January 20, 2006

I would like to thank the Department of Energy (DOE) for the opportunity to submit comments on the proposed changes to the ENERGY STAR CFL criteria. The following comments are submitted by CEE in response to Draft 2 of the criteria. They were developed by the CEE Lighting Committee (Committee) and are supported by the organizations listed below.

### Light Output of Slow-Starting Lamps

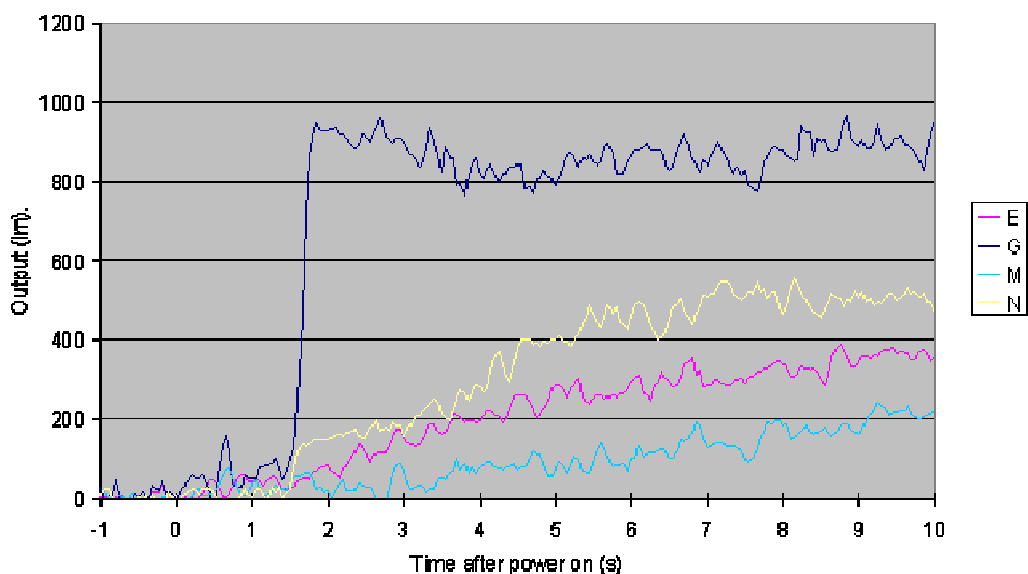
It has come to CEE's attention that there is some uncertainty among testing labs as to the definition of "full start" within the test for starting time. Testing labs do not have a definition of full start to use in their testing of starting time and are uncertain when to "stop the clock." We have provided a chart of slow start CFLs for DOE's reference, and suggest that the Department consider defining this metric to alleviate confusion. We recommend 15% or 20% of full light output as a starting point in the discussion about an appropriate definition.
